Agenda for 82nd PCC Meeting

EASTERN REGIONAL POWER COMMITTEE

AGENDA FOR 82ND PROTECTION SUB-COMMITTEE MEETING TO BE HELD AT ERPC, KOLKATA ON 19.08.2019 (MONDAY) AT 11:00 HOURS

Figure 1: Current measured at Barh PMU for 400 kV Barh - Kahalgaon - I during the tripping incident

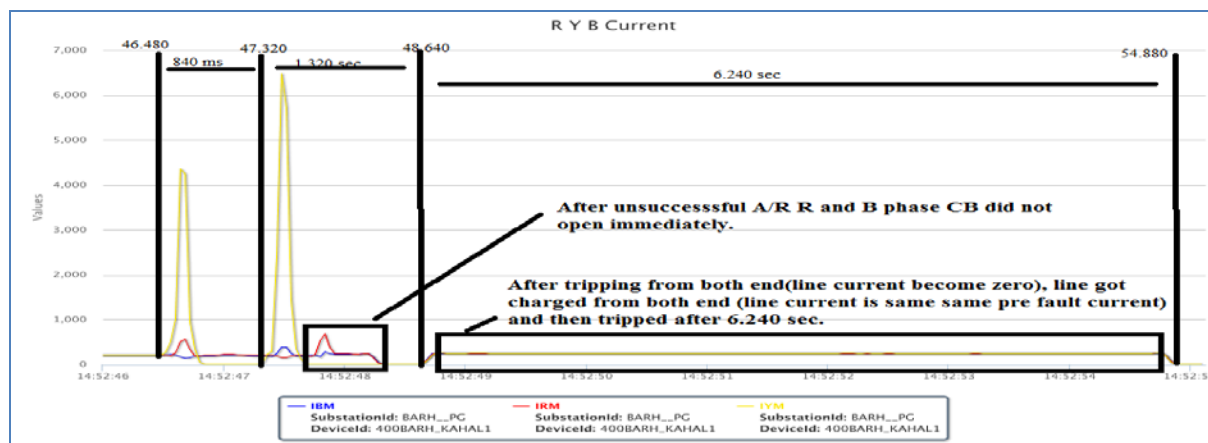
As per DR received (Attached in annexure-C8.1) from Barh end, R and B phase tie breakers did not open after unsuccessful auto reclose attempt of Y phase main breaker.

NTPC may explain.

Figure 2: Three phase current recorded at Bokaro for 400 kV Bokaro - Koderam - II

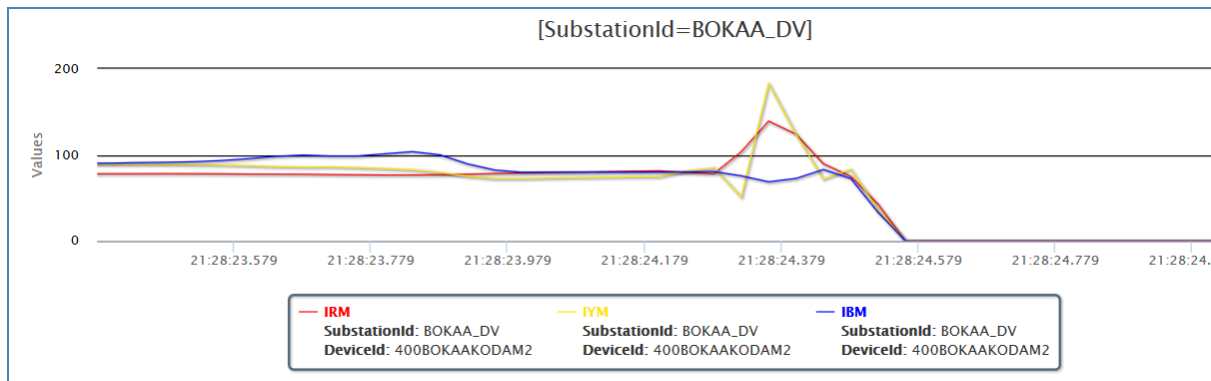
At 21:28 hrs on 24-07-19, 400 kV Bus Reactor I & II at Koderma and 400 kV Bokaro - Koderma – II tripped at 21:28 hrs. As per relay indication received, B/R I & II tripped on REF and 400 kV Bokaro - Koderma – II tripped on B-N fault at Koderma and DT receipt at Bokaro. As per current of 400 kV Bokaro – Koderma – II recorded at Bokaro PMU data (shown in figure-2), fault was not observed at the event of the operation.

DVC may explain.

Figure 3: Three phase current recorded at Kishangunj end for 400 kV Rangpo - Kishangunj S/C

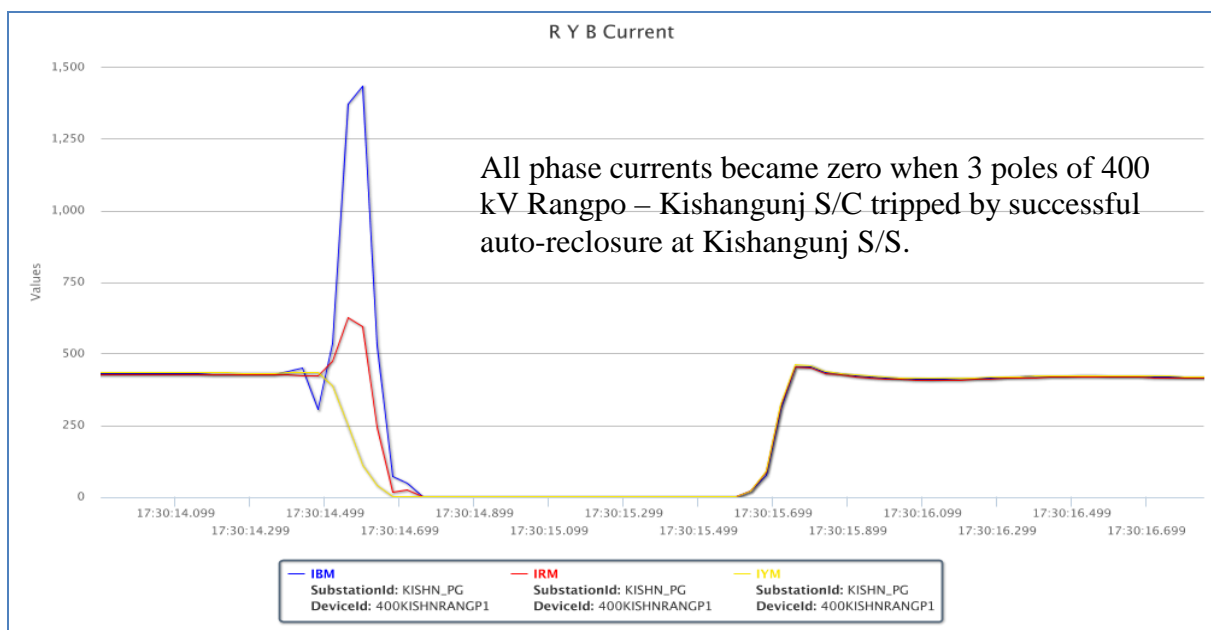
400 KV Kishangunj-Rangpo S/C successfully auto-reclosed at 17:30 hrs on 31-07-2019 due to B-N fault. From PMU analysis it is observed that after 1 sec of the tripping, single phase Auto-reclose was successful from Rangpo end whereas from Kishangunj end 3-phase Auto-reclose attempt was taken and it was successful. PMU observation recorded at Kishangunj S/S and Rangpo S/S are shown in figure 3&4.

POWERGRID and TVPTL may explain.

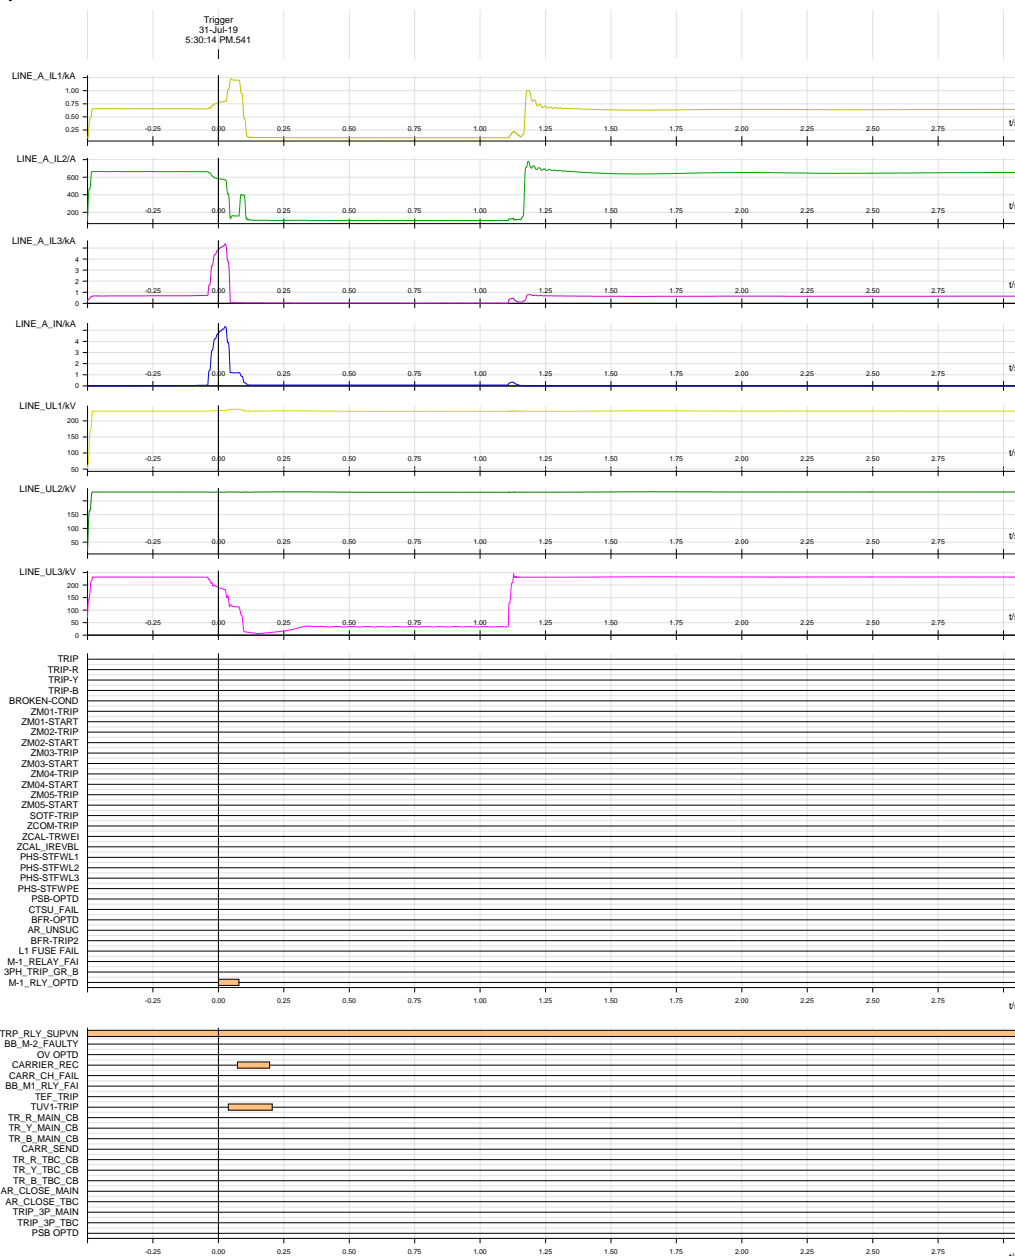
As per DR recorded at Rangpo end, digital signal for D/P triggering, D/P trip, main CB/tie CB operation etc. are not recorded in DR.

Figure 6: DR at Arrah end for tripping of 220 kV Arrah - Khagul S/C on 12-06-19 at 15:24 hrs

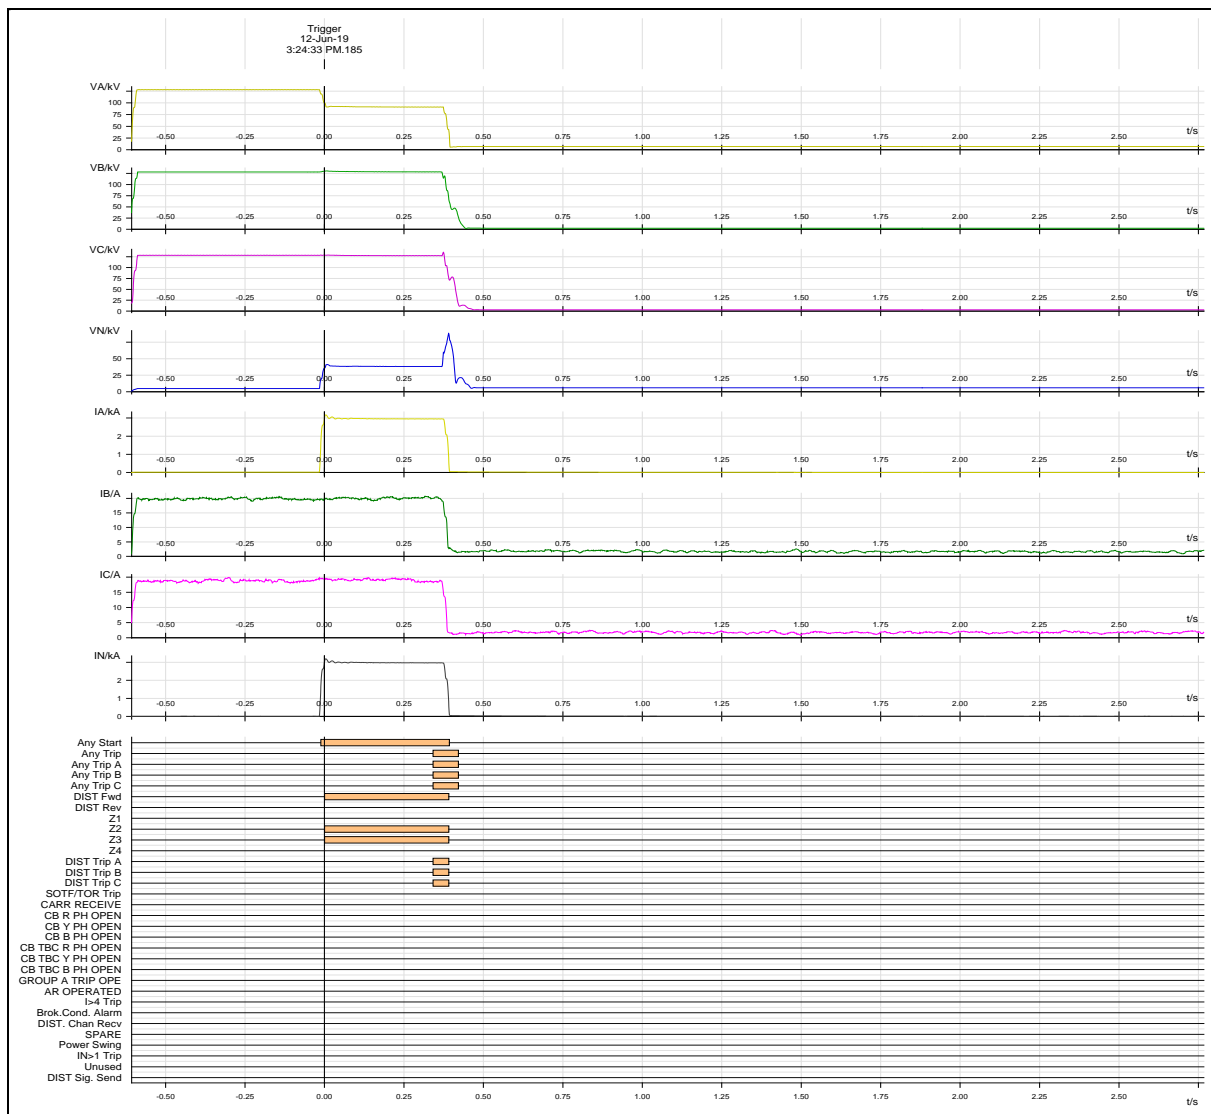
As per decision taken 67th PCC meeting, during anti-theft charging Time delays for Zone-1, Zone-2 and Zone-3 should be made instantaneous. But 220 kV Arrah - Khagul S/C tripped on 12-06-19 at 15:24 hrs where fault clearing is zone-2 timing and the line was idle charged from Arrah end.

DR output of 220 kV Arrah – Khagul S/C at Arrah end for the tripping on 12-06-19 at 15:24 hrs is given below.

Powergrid may explain.

Figure 7: DR recorded at Kharagpur end for tripping of 400 Kharagpur-Chaibasa-II on 04-05-2019 at 02:28 hrs

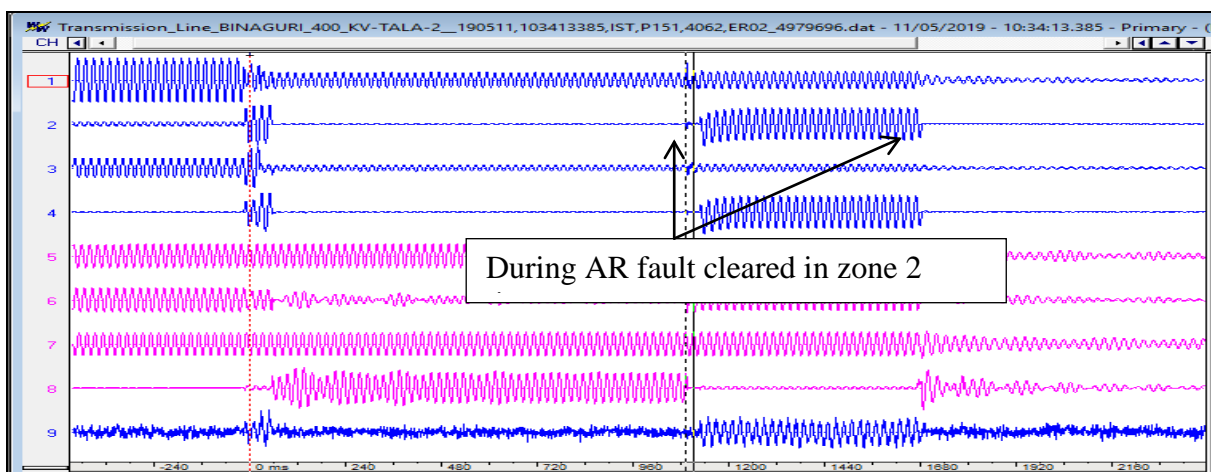
Sr No.	Tripping date & time	Line Name	Discrepancies observed in the tripping
1	04-05-2019 at 02:28 hrs	400 Kharagpur-Chaibasa-II	WBSETCL to share the reason for not sending the carrier from Kharagpur end. Fault cleared from Chaibasa end in Z-II timing in spite of being auto-reclose from Kharagpur end (Figure 7)
2	05-05-19 at 08:54 hrs	400 KV Malda Purnea-II	POWERGRID to share the reason for delayed fault clearance (140 ms) at Malda end . Dead time at Malda end may be reduced from 1320 ms to 1000 ms. (Figure 8) POWERGRID to share reason for opening of all the 3 poles of Main CB immediately after the fault and reason for auto reclose attempt of tie CB 2.1 sec after the fault. (figure 9)
3	11-05-19 10:34hrs	400 kV Tala Binaguri-II	During auto-reclose from Binaguri end, fault was cleared after 500 ms. POWERGRID may enable

TOR protection at Binaguri end.
4.	13-05-19 10:44 hrs	400 KV Malbase Binaguri	POWERGRID may share the reason for opening of all three poles at Binaguri end 600 ms after the fault. In the faulted phase (which was in its AR cycle) suddenly 476 kV induced and TOV ST-1 started at Binaguri end. Reason for such high voltage induced in faulted phase may be investigated. Reason for non-operation of TOV ST-2 at Binaguri end may also be checked.

DR recorded at Tashiding end of 220 kV Tashiding Rangpo S/C at 10:35:11.671 hrs

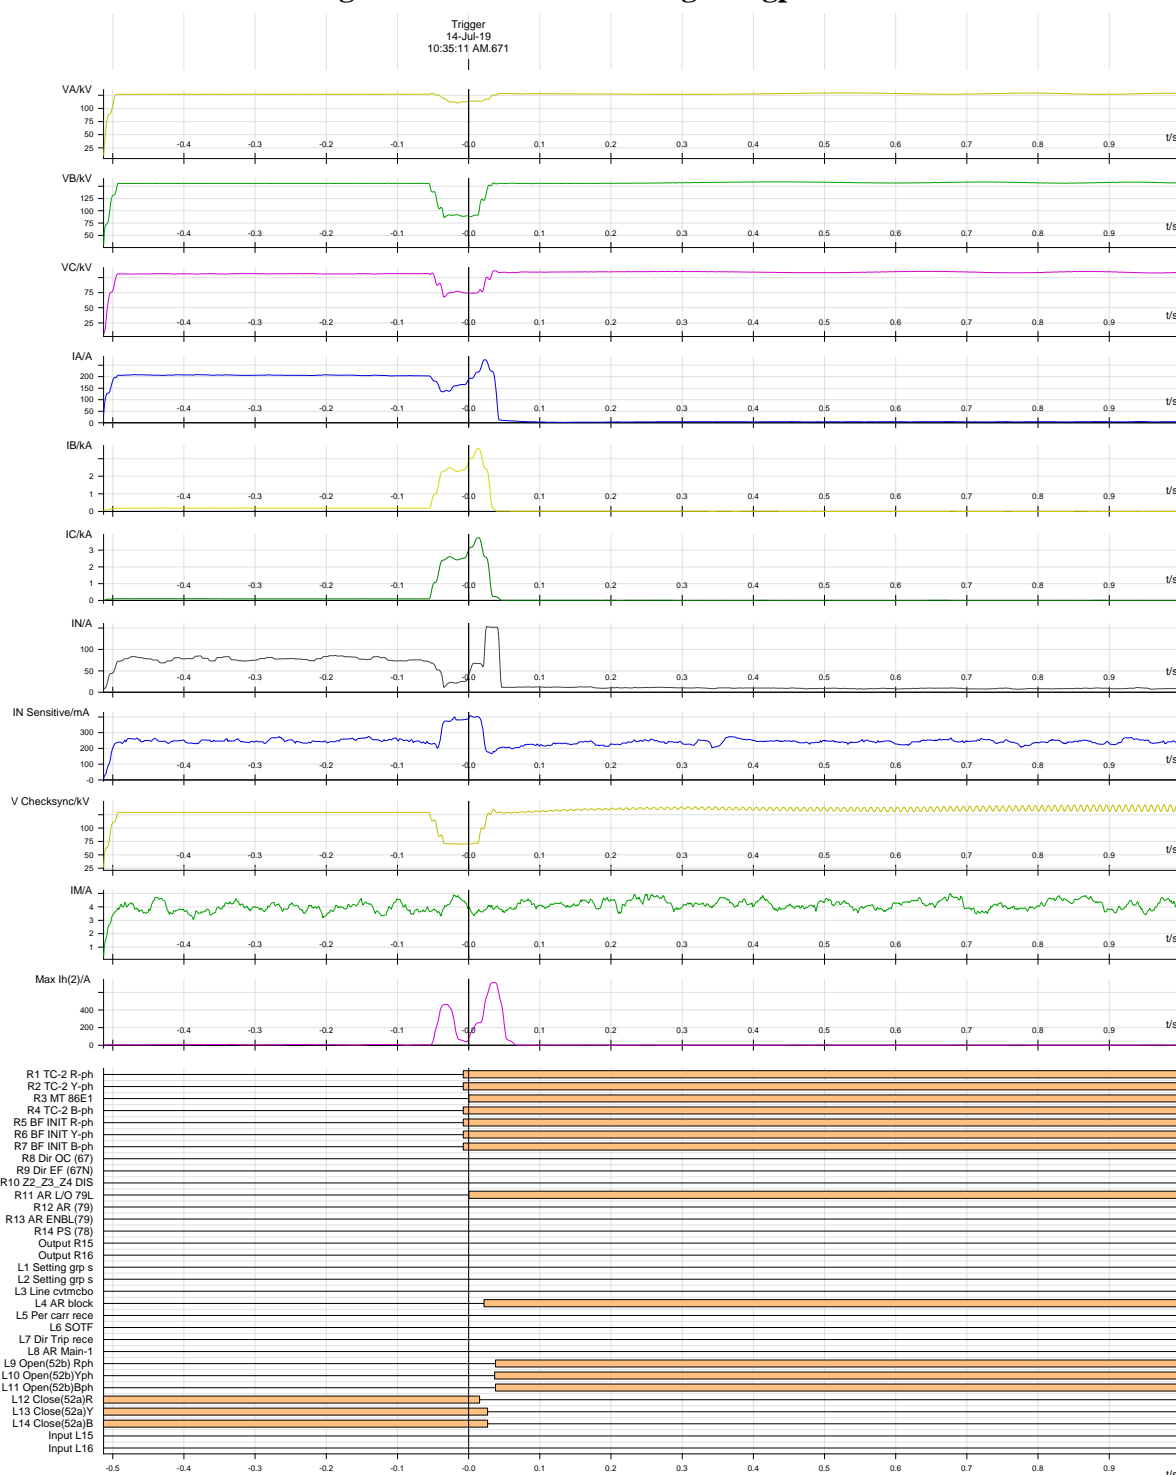
Y-B, F/C 3.48kA in Y phase & 3.63 kA in B phase. Digital channels of DR outputs may be configured as per recommendations given in 79th PCC meeting. **B phase current was low as 60 A (Other two phase current was around 200A) prior to the tripping.**

DR recorded at Tashiding end of 220 kV Tashiding New Melli S/C at 10:35:11.656hrs

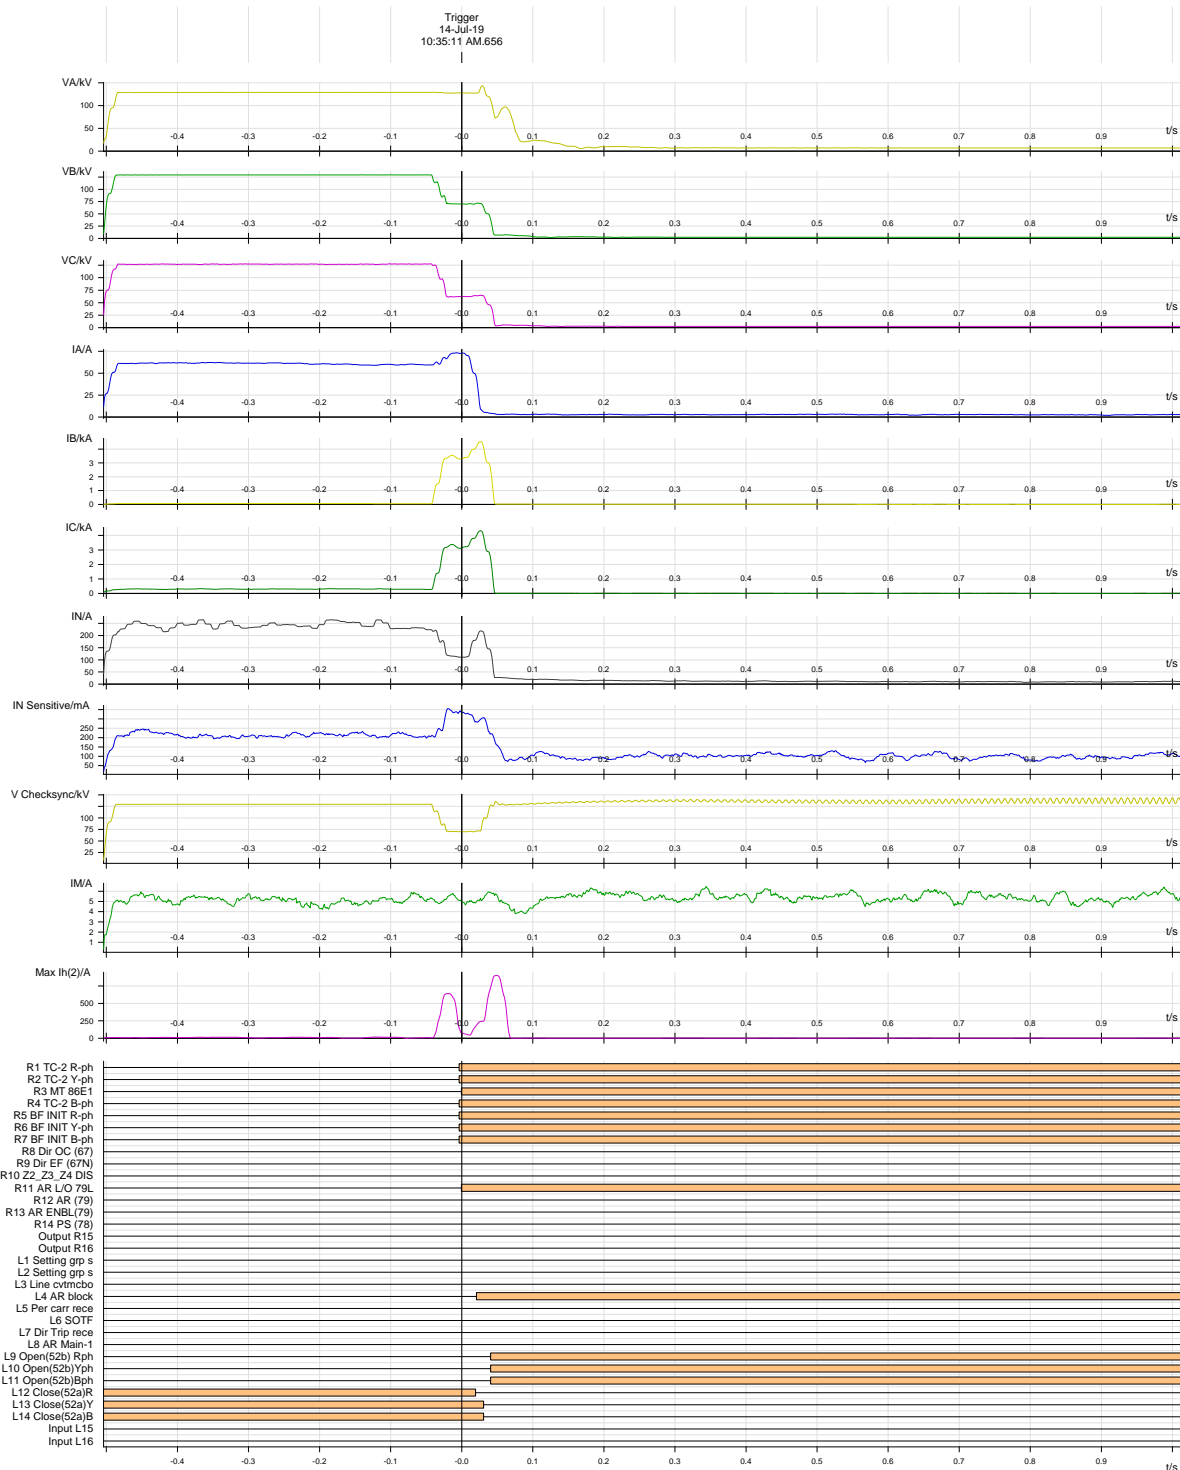
Y-B, F/C 3.81kA in Y phase & 3.61 kA in B phase. Digital channels of DR outputs may be configured as per recommendations given in 79th PCC meeting. **B phase current was high as 300 A (Other two phase current was 60 A) prior to the tripping.**

DR recorded at Jorethang end of 220 kV Jorethang New Melli I at 10:35:11.640 hrs

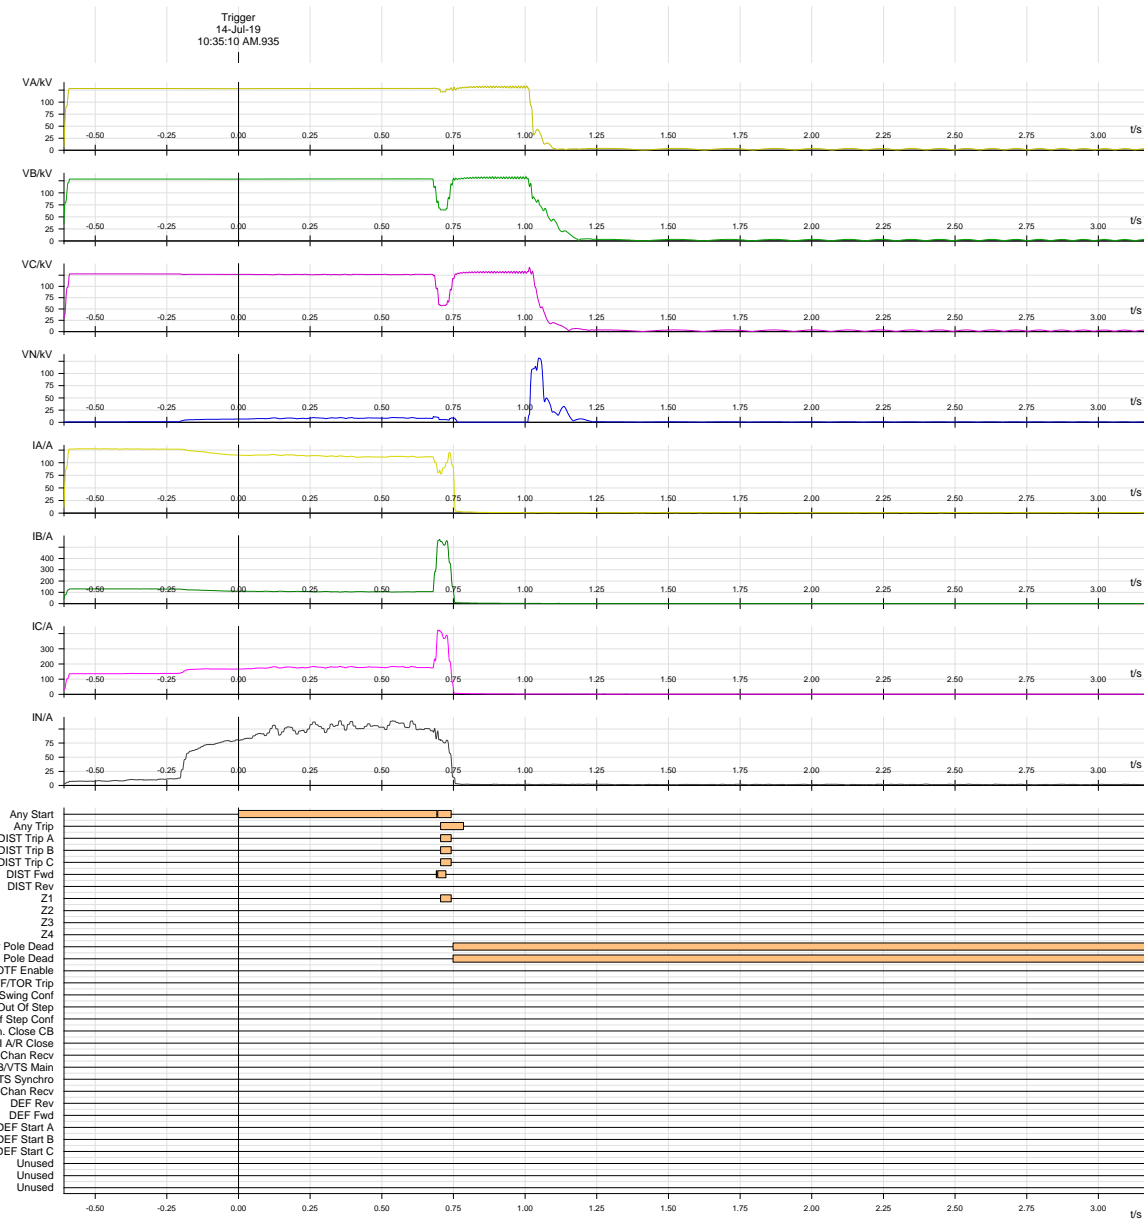
Y-B, F/C 0.5kA in Y phase & 0.3 kA in B phase. Digital channels of DR outputs may be configured (Z-II, Z-III & Z-IV pick ups was not available) as per recommendations given in 79th PCC meeting. **B phase current was high as 180 A (Other two phase current was 100 A) prior to the tripping.**
